**Vestavia Hills
Design Review Board Agenda
May 1, 2025
6:00 PM**

1. Call to Order
2. Roll Call
3. Approval Of Minutes
4. **DRB-25-6** Neil Shah is requesting **Architectural Review, Landscape Review, & Final Review Of Materials** for the property located at 1030 S. Liberty Rd. The purpose of this request is for a new building. The property is owned by Neil Shah and zoned Vestavia Hills PB.
5. Time Of Adjournment

GODDARD SCHOOL LIBERTY PARK VESTAVIA HILLS, AL LOT #3B of Bray Town Center Phase II

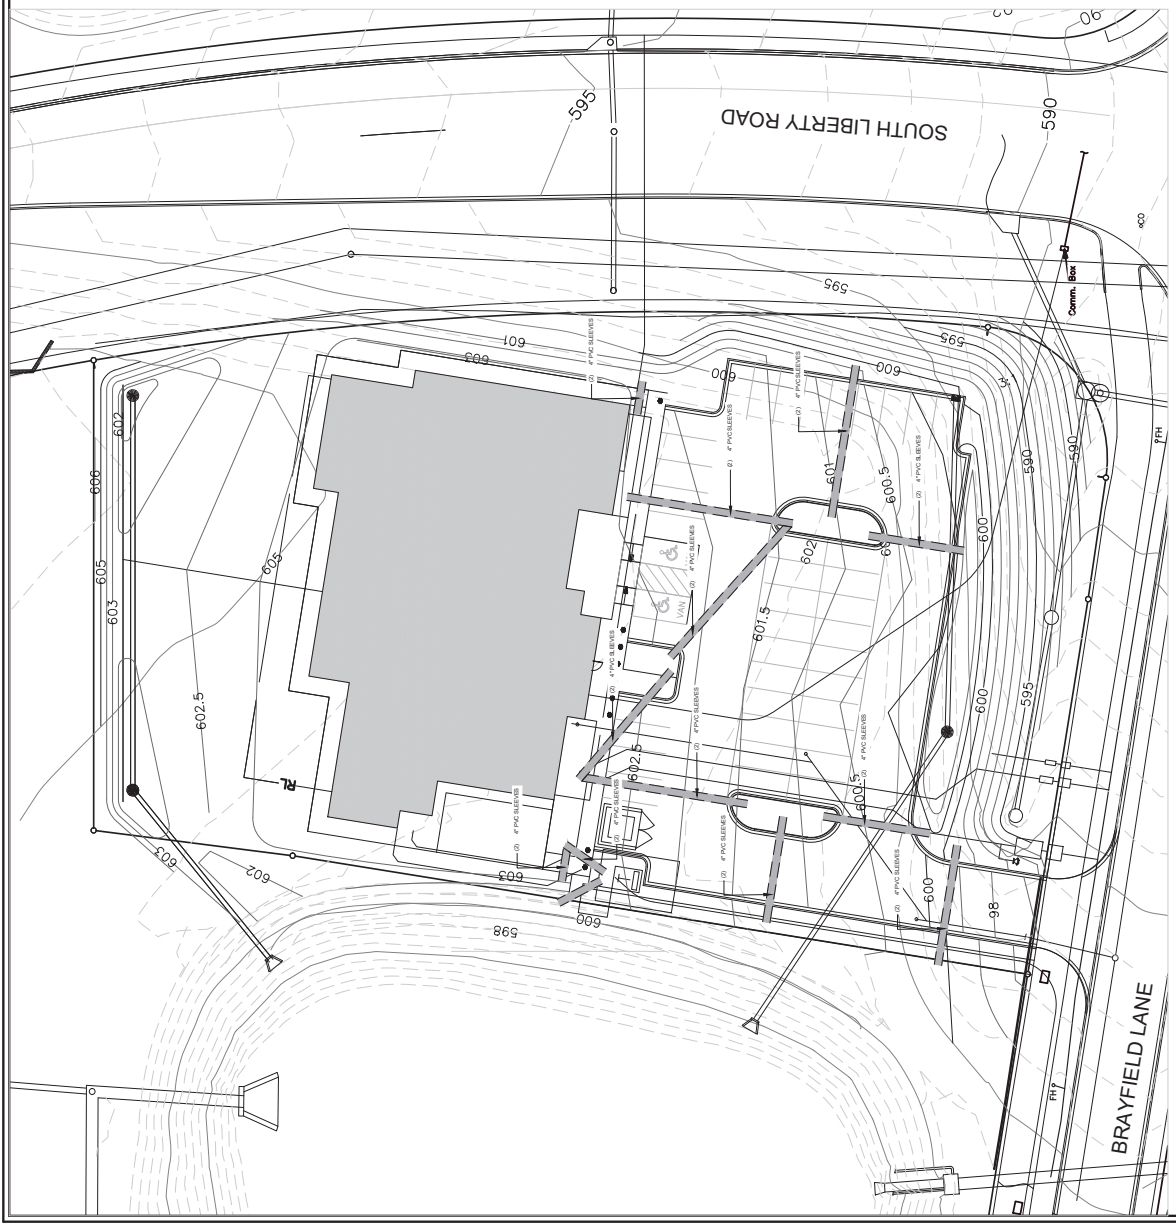
- provide physical color sample of monument sign lettering for approval
- hldy sign on front - legs no more than 36", lettering no higher than 24"
- provide updated landscape plan to screen play equipment with evergreen plantings
